Service Bulletin

Forward Fresh Air Ventilation System Retrofit

Document: Service Bulletin SB-GA8-2005-19

Figure 1: Installation drawing showing the right forward side skin from inside the aircraft.

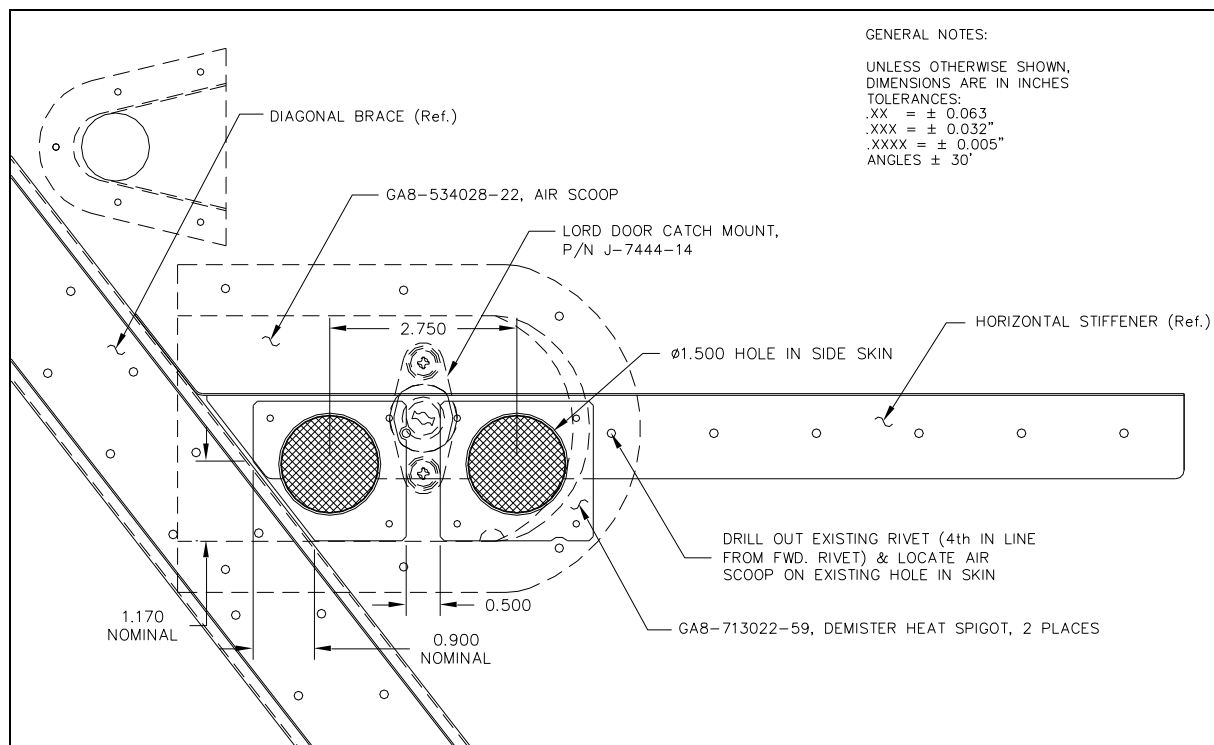
3. Disconnect existing SCAT6 ducts from their respective forward side vent assemblies, P/N GA8-534017-11.
4. Two spigots are to be attached to each of the left and right forward side skin, P/N GA8-534023- as per figure 1. Trim the forward spigot such that it will abut the horizontal stiffener, P/N GA8-534023-61(R)/-39(L) and the diagonal brace, GA8-534023-35 (from S/N GA8-00-004 up to and including S/N GA8-04-048) or P/N GA8-534023-83 (S/N GA8-04-049 and subsequent). Refer to figure 1 for key dimensions regarding spigot installation.

10. Locate the air scoop to the drilled out hole to the middle hole at the aft end of the air scoop.
11. Ensuring that the air scoop is level, drill 1/8" (#30 or 3.3mm) clearance holes through the air scoop and side skin as per figure 1. Temporarily secure the air scoop to the side skin.

15. Mark and drill 5/32" (#21 or 4.0mm) clearance holes in the side skin and install the Lord door catch mount in accordance with figures 1 and 2. Lord door catch mount may be further spaced with AN960-10 washers as required for flush finish with the air scoop.

Figure 2: Installation of Lord door catch mount.

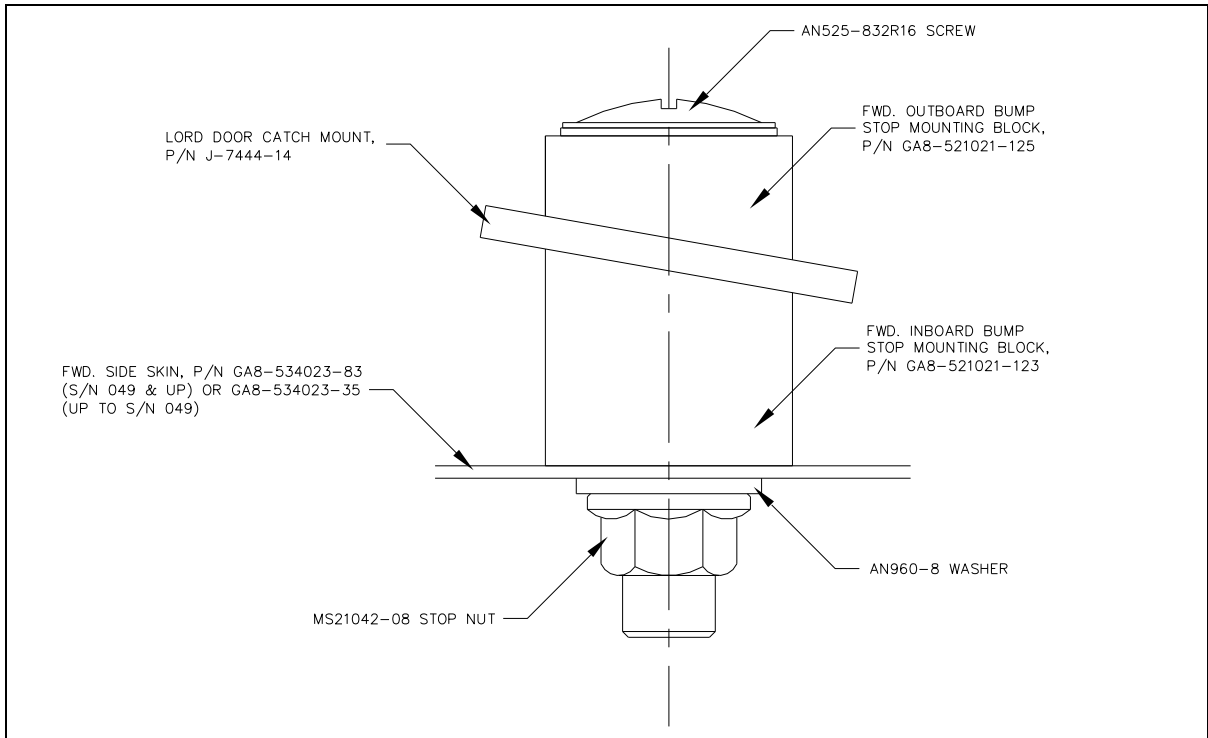
13. Cut a 1.000"±0.063" (25.400mm±1.588mm) hole in the air scoop centred on the point where the Dzus lines up.
14. Fit the Lord door catch mount into the air scoop with the "LORD" label upright and the holes in the base aligned vertically between the two spigot openings.
